**ADDENDUM
NO. 02**

**Franklin Central High School Addition and Renovations Phase 3A.1
6215 S. Franklin Rd
Indianapolis, IN 46259**

ADDENDUM NO. 2 (TWO)

DATE: March 28, 2025
PROJECT: Additions & Renovations to Franklin Central High School
Phase 3A.1
OWNER: Franklin Township Community School Corporation
PROJECT NO.: 2024040.00

Drawing No.: **MP1V.A**

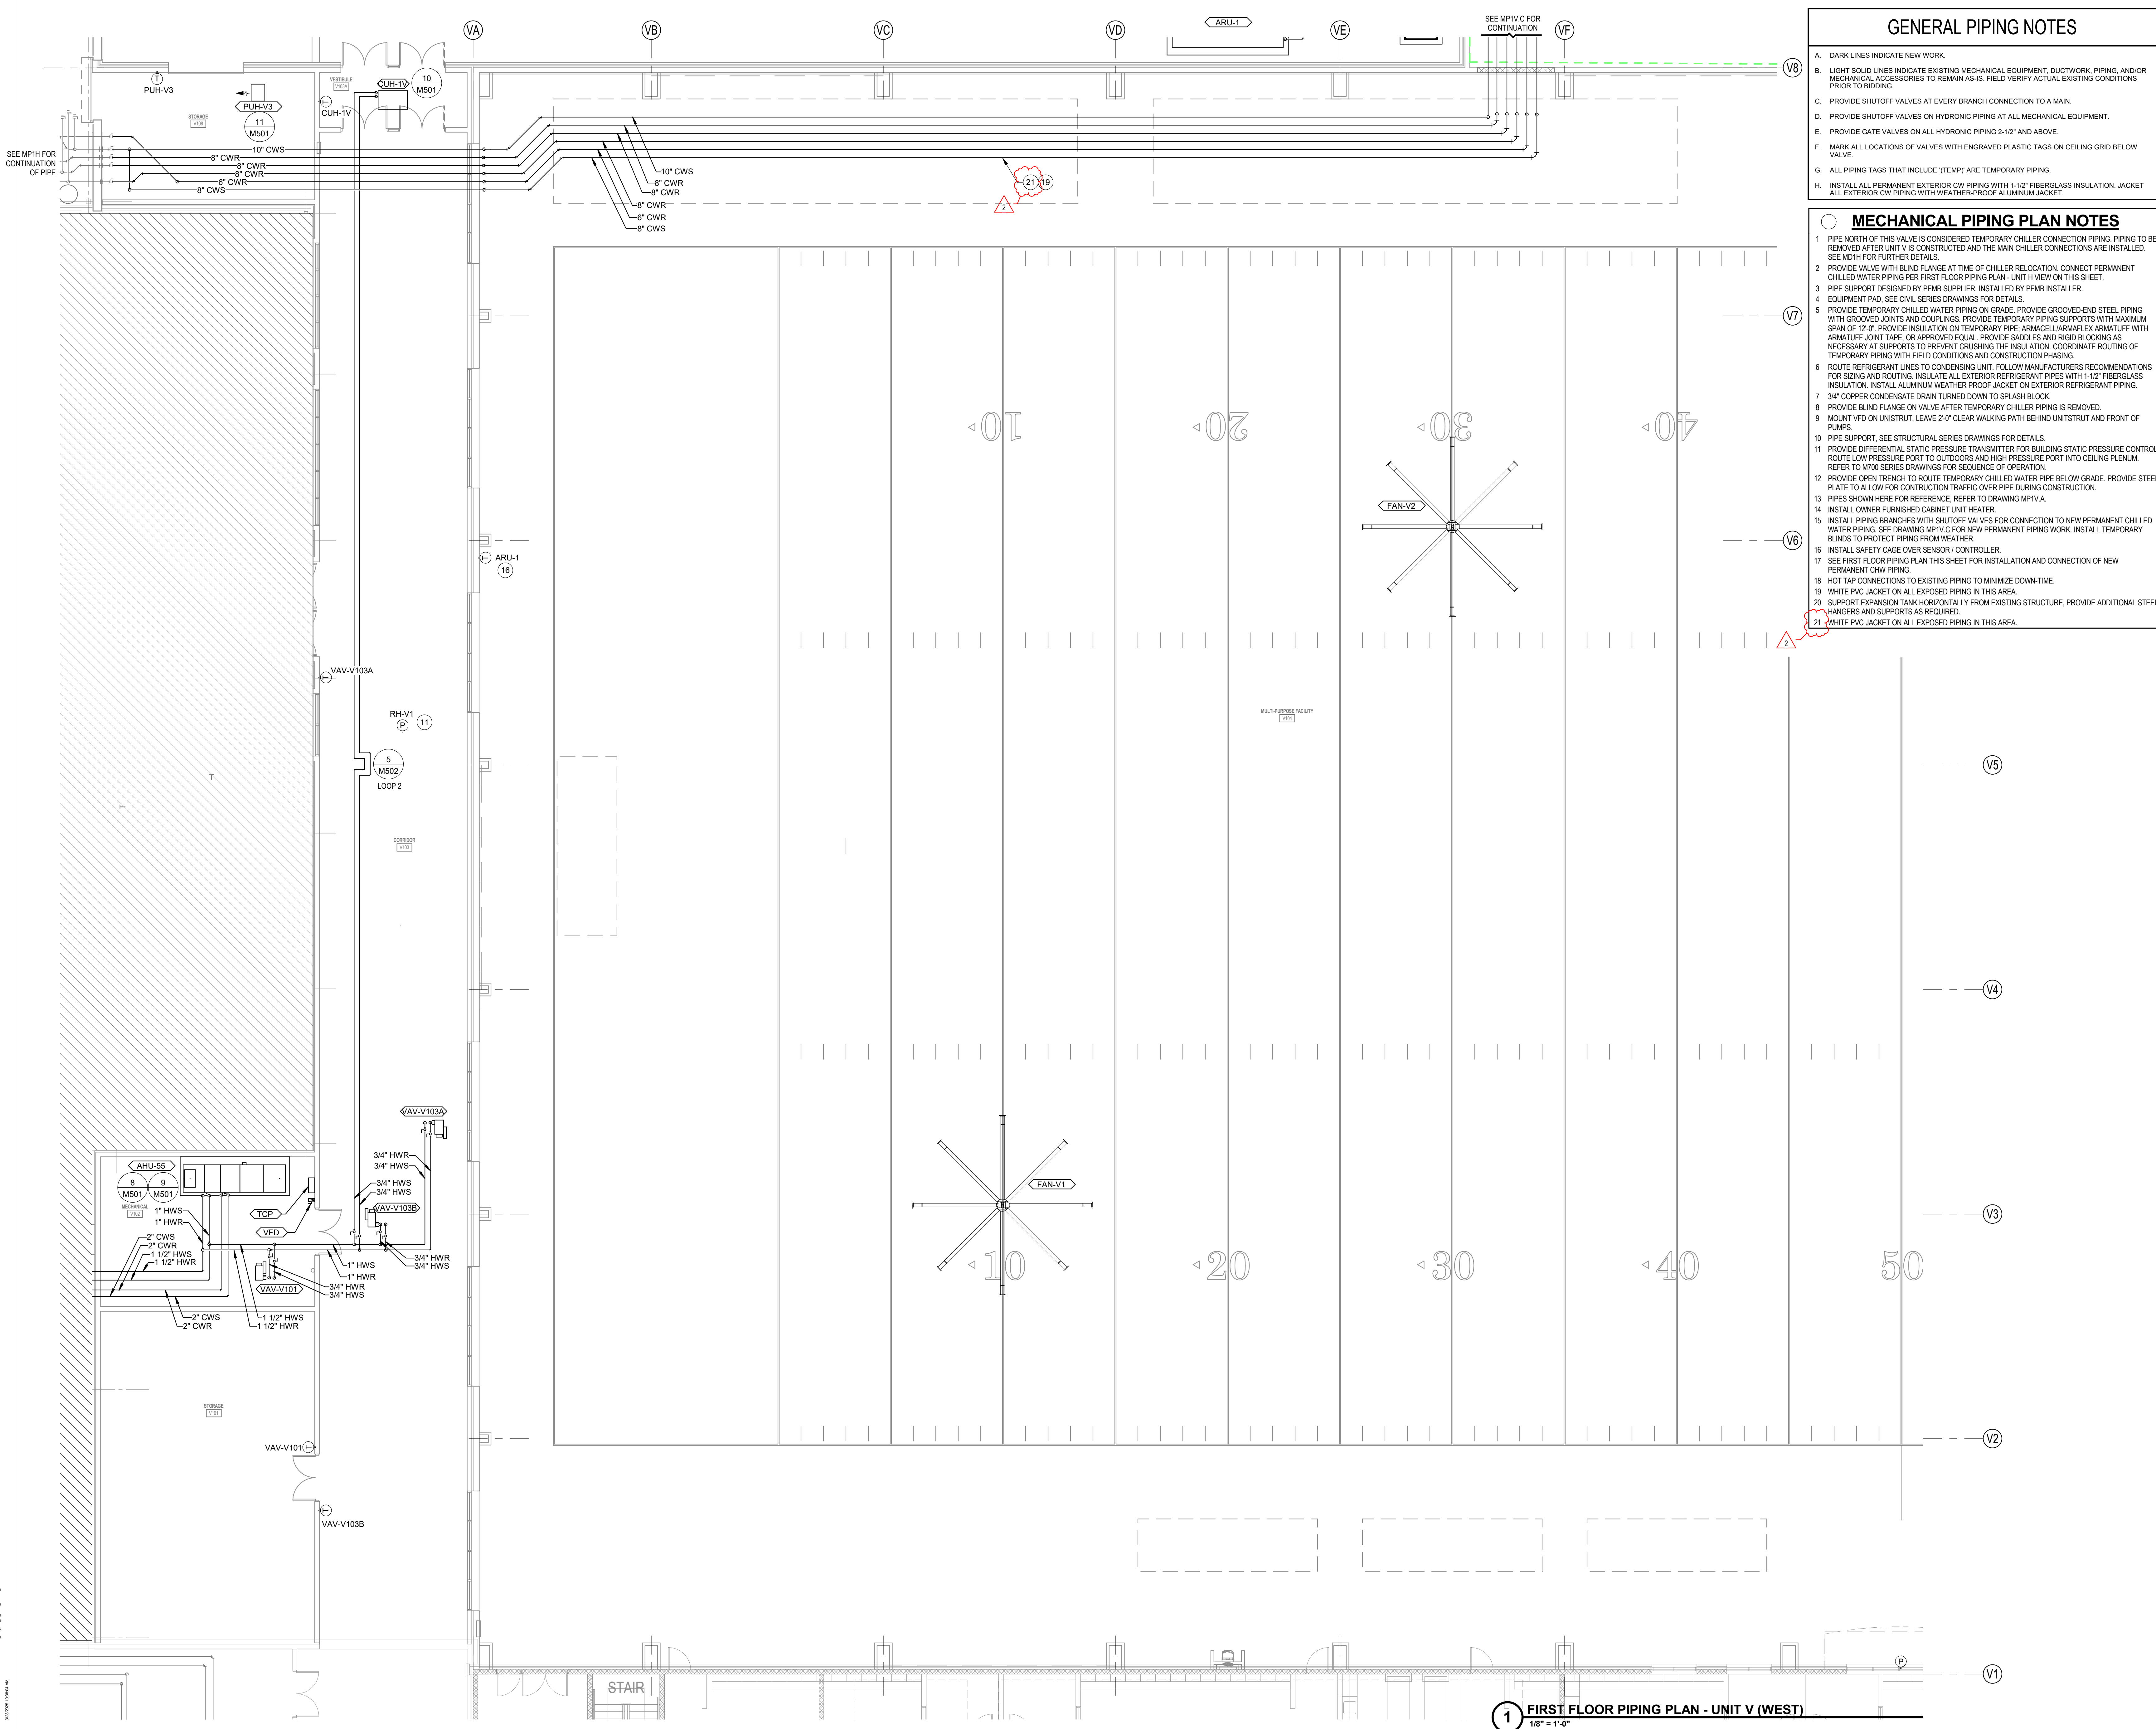
- 2-11 MP1H: Replace drawing in its entirety with attached revision.
- 2-12 MP1V.A: Replace drawing in its entirety with attached revision.
